PROJECT SCOPING PLAN FOR PERFORMING A
CERCLA REMEDIAL INVESTIGATION/FEASIBILITY
STUDY (RI/FS) AT THE MUNITIONS WASHOUT FACILITY
AND LEACH FIELD, SENECA ARMY DEPOT ACTIVITY

OCTOBER 1996

**PROJECT SCOPING PLAN
REMEDIAL INVESTIGATION/FEASIBILITY STUDY
AT SEAD-4
SENECA ARMY DEPOT ACTIVITY
ROMULUS, NEW YORK**

**Parsons Engineering Science, Inc.
Prudential Center
Boston, Massachusetts**

**FIGURE 4-3
PROPOSED AND EXISTING MONITORING WELL
AND STAFF GAUGE LOCATIONS**

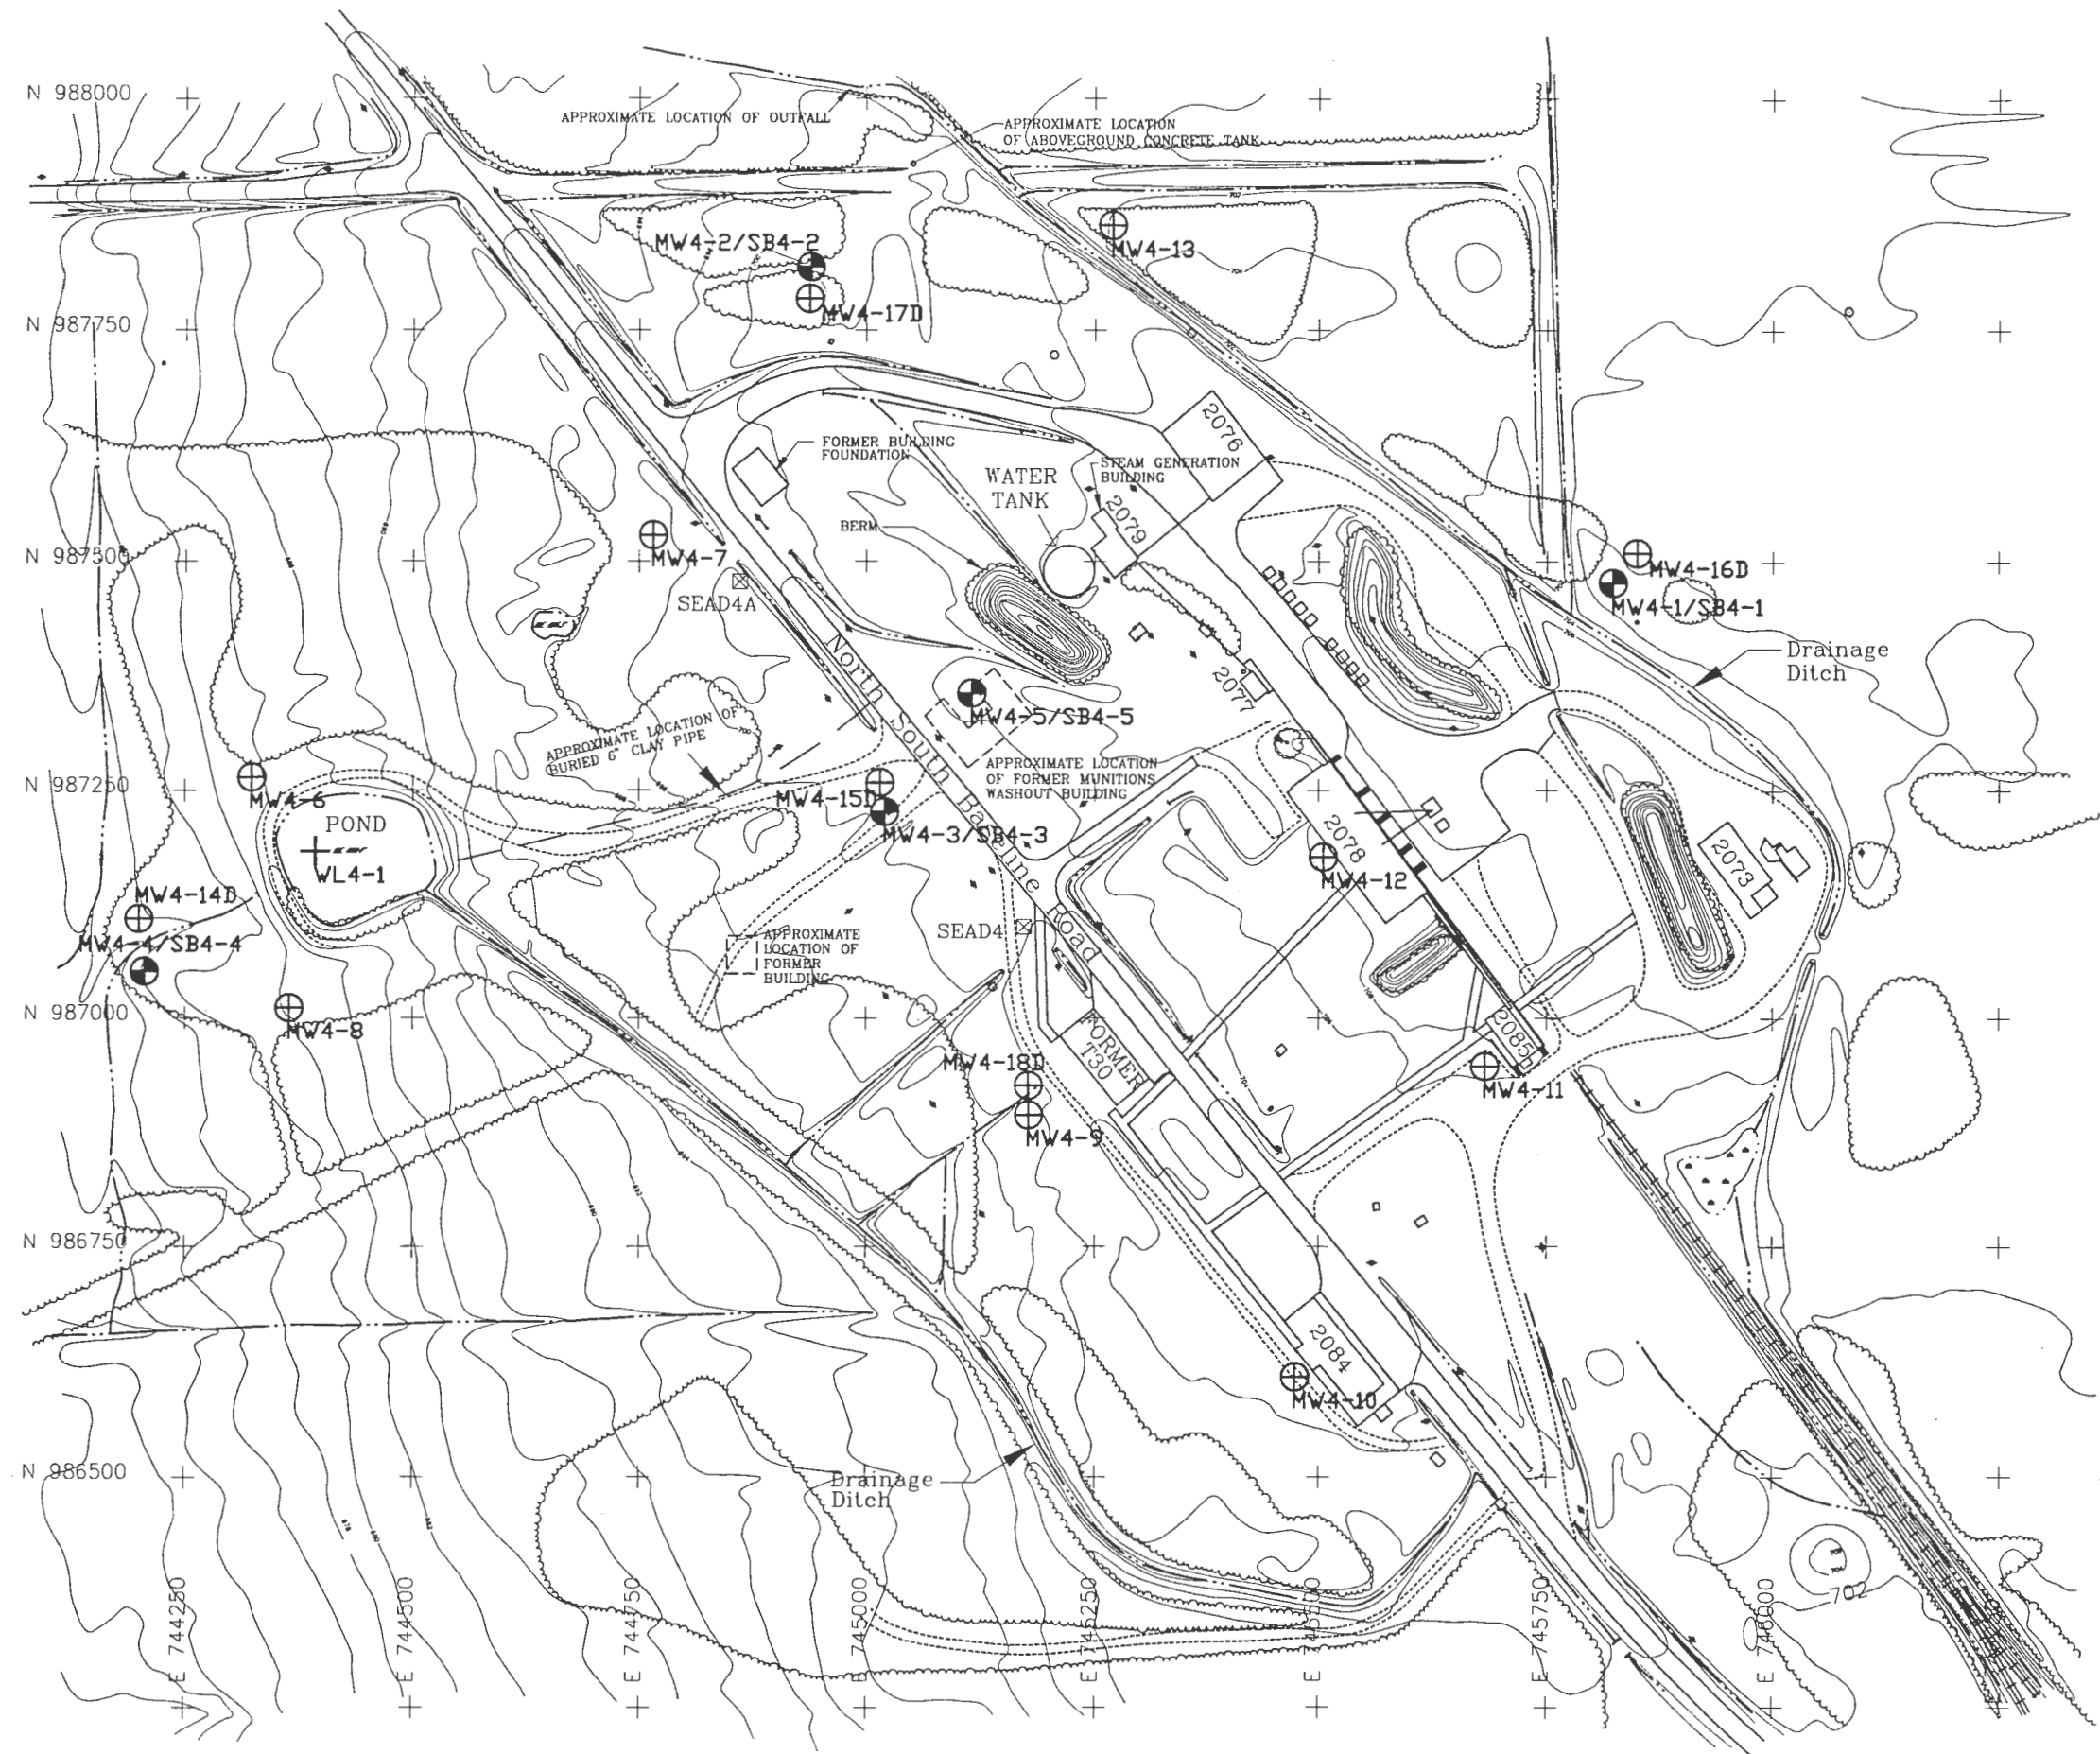
Comment #16 Figure 4-3: The work plan proposes to install three additional monitoring wells to the west of the pond to evaluate possible radial flow from the pond. Radial flow may occur from the pond but given its size the horizontal effects of any such radial flow is likely to be limited. It is recommended that the westernmost of these proposed wells (MW4-7) be relocated. The proposed location is on the west side of North South Baseline Road, downgradient of the former building foundation. This location will provide for monitoring of this former building as well as additional monitoring of the suspected leach field.

- Comment #9** Page 4-10, 4.2.5. The sixth paragraph identified an additional monitoring well to the northeast of the site to supplement the existing background monitoring well. This reviewer could not locate this monitoring well on Figure 4-3. Also, provide rationale for an additional background well.

Response #16 Agreed. The proposed well MW4-7 was moved to the recommended location. The changed was made to Section 4.2.5 and Figure 4-3

Agreed. A staff gauge will be installed in the pond and surveyed to help evaluate radial flow from the pond. The changes was made to page 4-10 and Figure 4-3 of the Scoping Plan.

Agreed. The proposed background well (MW4-13) was moved to the northeast side of the northwest-southeast trending drainage ditch. The Change was made on Figure 4-3.

Agreed. To address the potential for impacts to the bedrock aquifer and to define vertical gradients, 5 shallow bedrock wells were added to the SEAD-4 RI/FS Scoping Plan. These five wells will result in 5 paired wells each consisting of one till/weathered shale well and one shallow bedrock well. Pages 4-12, 4-14, and 4-19 and Figure 4-3 were amended. Table 4-1 was also updated.
